CUNO-330.2
10/764,717

PATENT
June 27, 2005

IN THE DRAWINGS:

REMARKS

2/6

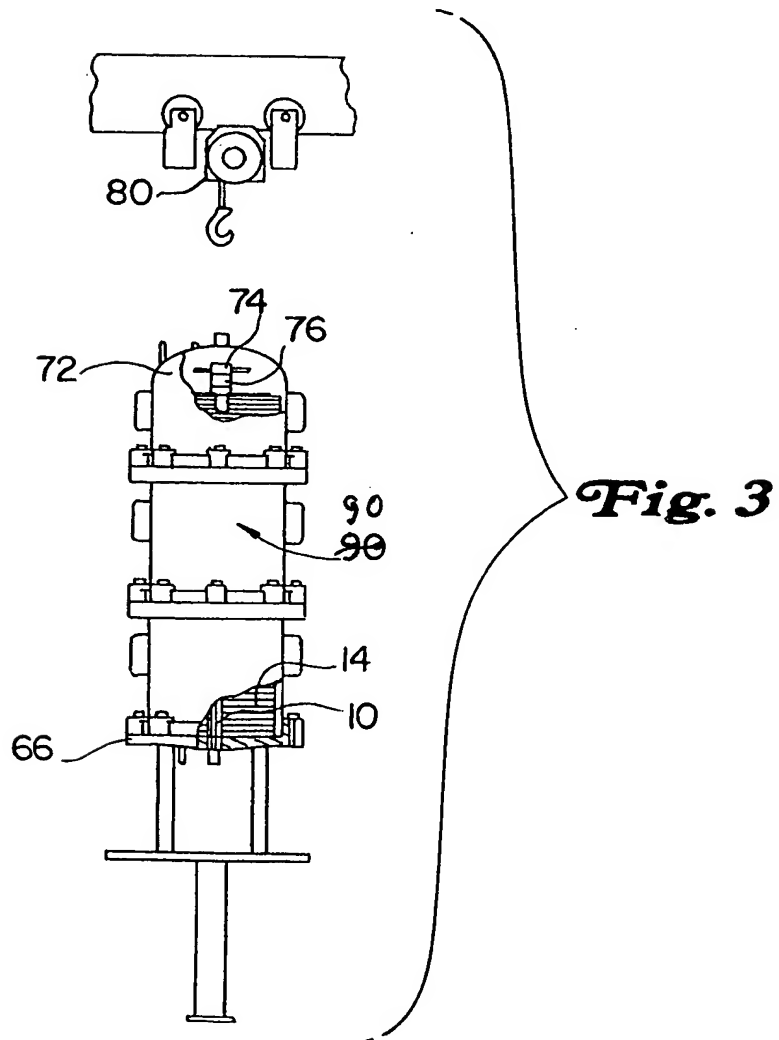
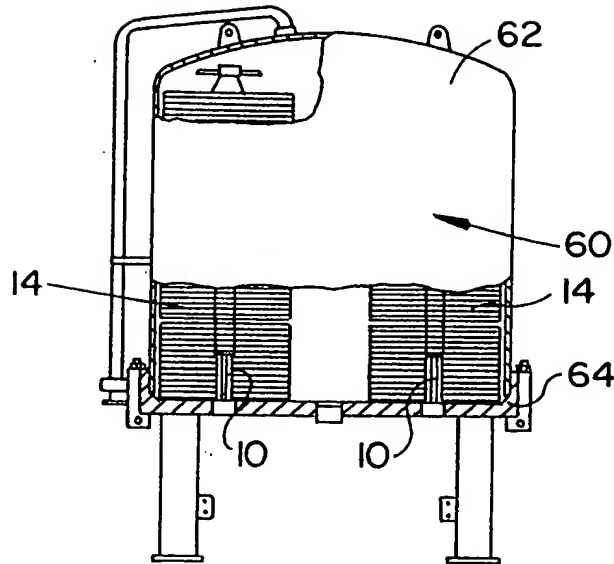
Please replace Sheet 2/6 (Figure 3) and sheet 6/6 (Figure 9C) with the new Sheets 2/6 and 6/6 enclosed herewith. A copy of the replacement sheets 2/6 and 6/6 is being sent to the official draftsman concurrently herewith.
